Stevens TR05 Adequacy Review Letter

2/15/2019 Stevens Mine Permit M1996064

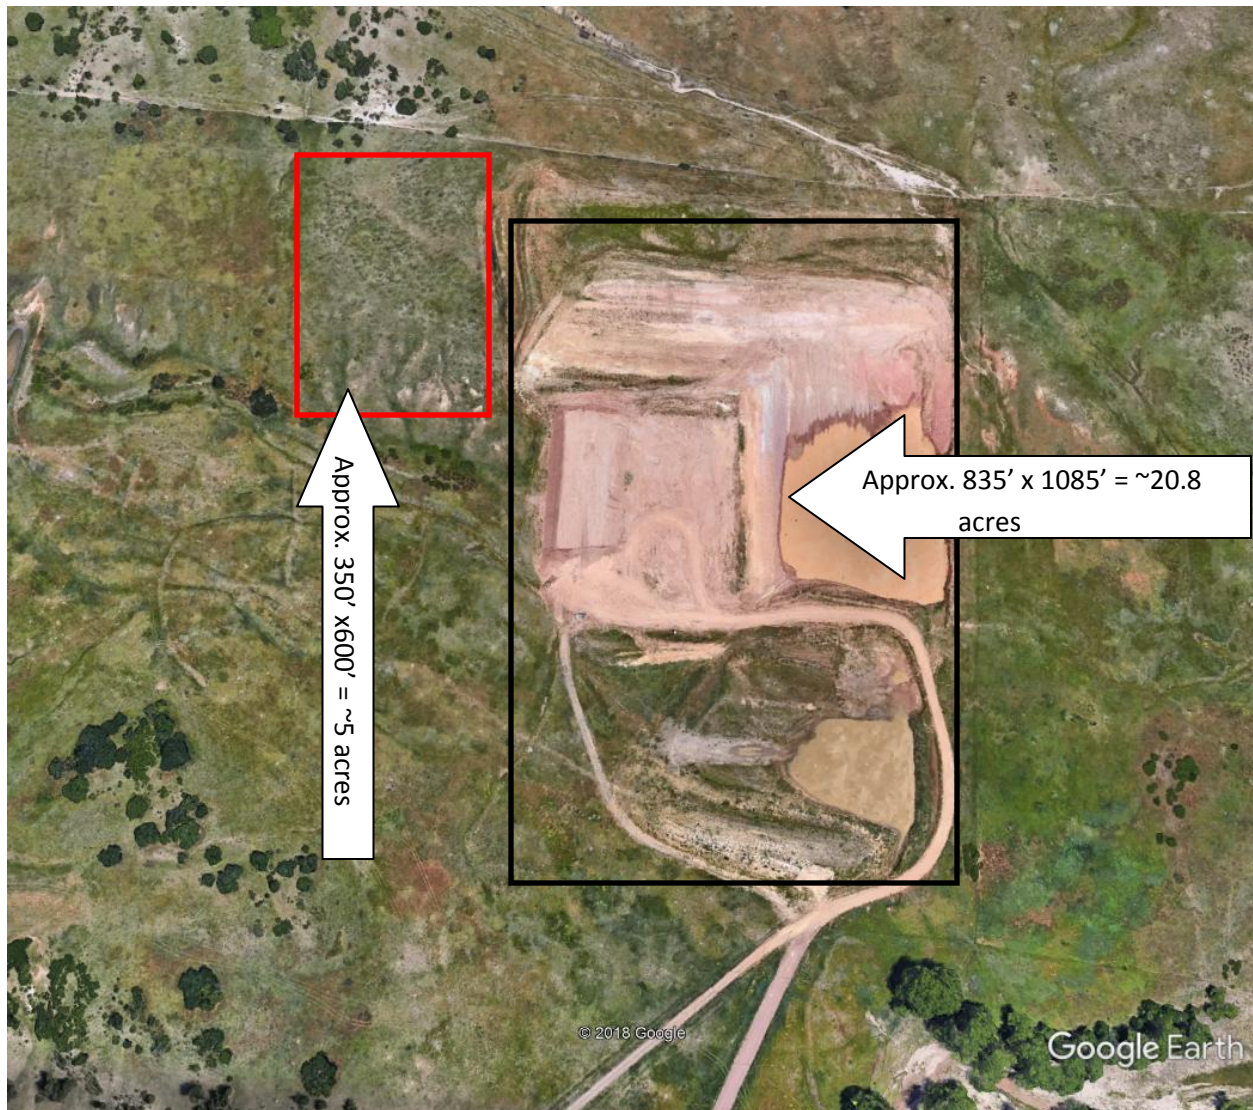
1. Exhibit D – Mining Plan: Acme is asking that the allowable disturbed area be increased from 20.8 acres to 26 acres. This additional acreage would allow for on-site material to be used in conjunction with the overburden stock piles to backfill the pit area. Thus, possibly eliminating the need to import fill material. The new affected area would be in the northwest quarter of the permitted area.

What is proposed on the map can not be done through the technical revision process. You would be required to amend the permit application to add additional disturbed acreage to the permit area. All aspects of the permit would need to be updated and you would need to go through the public notice process.

Sorry for taking so long to respond. We were waiting for more information from our superiors. Yes I would like to withdraw the technical revision at this time to re-write a new TR. I have downloaded a copy of the application and have discussed to some degree with upper management. It sounds like there is some interest from other brick companies. Not certain how serious at this time.
